Well Name: TAILS CC 10_3 FED COM	Well Location: T24S / R29E / SEC 10 / SWSE / 32.225447 / -103.969274	County or Parish/State: EDDY / NM
Well Number: 35H	Type of Well: OIL WELL	Allottee or Tribe Name:
Lease Number: NMNM081616	Unit or CA Name:	Unit or CA Number:
US Well Number: 3001548965	Well Status: Drilling Well	Operator: OXY USA INCORPORATED

Notice of Intent

Sundry ID: 2667031

Type of Submission: Notice of Intent	Type of Action: APD Change
Date Sundry Submitted: 04/14/2022	Time Sundry Submitted: 10:01
Date proposed operation will begin: 04/12/2022

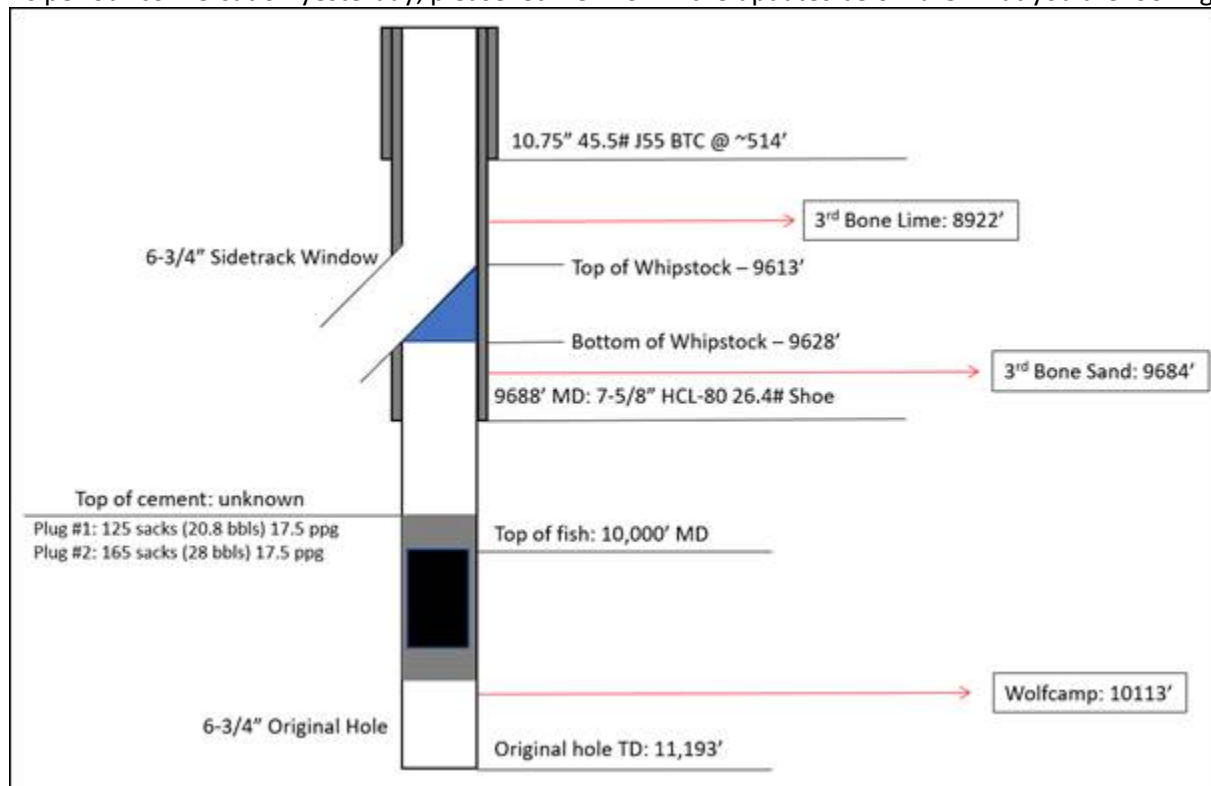
As per our conversation yesterday, please let me know if the updates below are what you are looking for.

This looks great thank you.

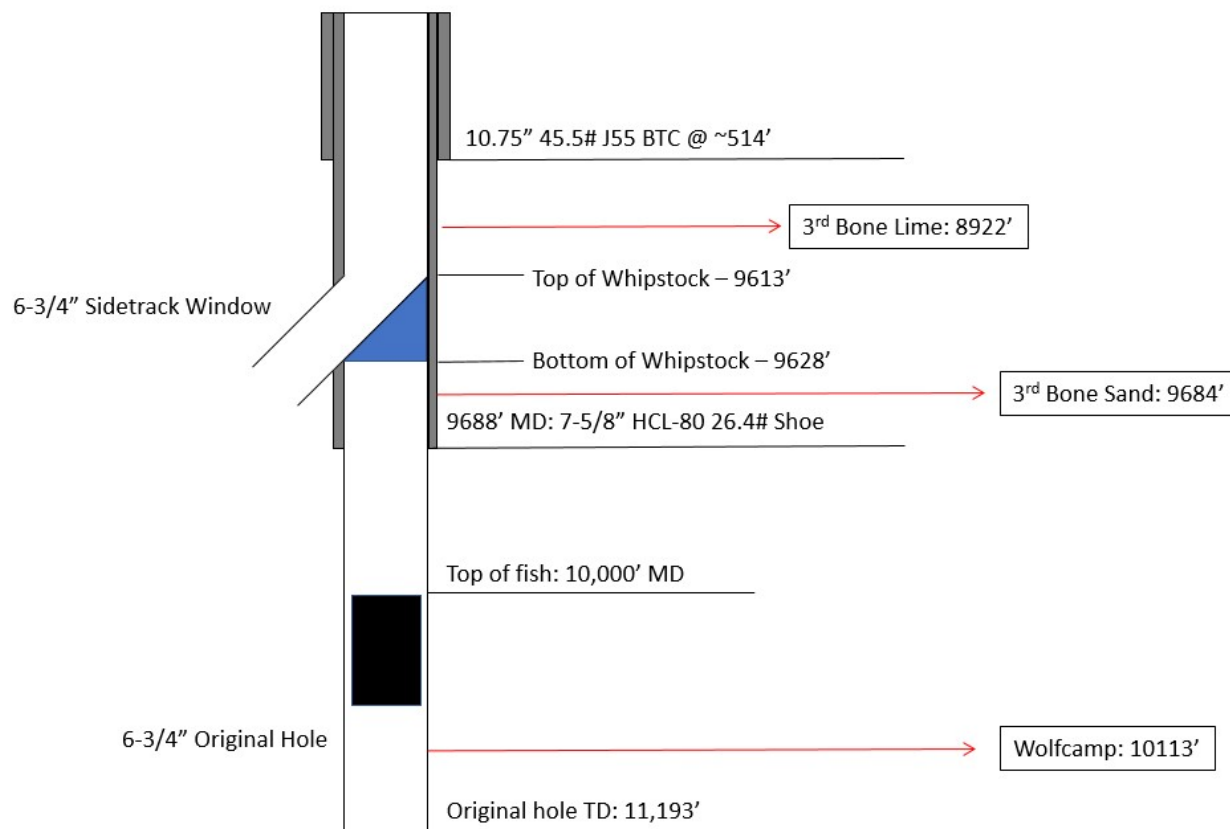
See wellbore diagram below. As mentioned, the two sidetracks off of cement plugs were unsuccessful. Our plan was to tie back production cement 500' into the sidetrack window to isolate both wellbores.

After two unsuccessful attempts to sidetrack off of cement plugs in openhole, it was decided to set a cased hole whipstock ~60' above the intermediate casing shoe (Still in 3rd Bone Spring Lime). We will plan to bring production cement 500' inside window for isolation. Please provide verbal approval, or let us know if you need any more information. I'm assuming we will need to submit another sundry with this updated plan.

Original hole TD: 11,193'

Top of fish: 9,940'

7-5/8" shoe depth (previous casing): 9,688'

Bottom of sidetrack window: 9628'

This looks good, please submit this along with the official sundry into AFMSS at your earliest convenience.

I have no problem with this, the only difference between my email and Chris's is as the approving engineer I am just requesting the required documents for the approval of the procedure.

Calen,
You are good to proceed with your plan, please submit a sundry updating the proposed plan and notify me via email when it is in the system. For future drilling request outside business hours, please call the 24 hr on-call phone at 575-706-2779. Emails are not monitored 24 hrs a day.
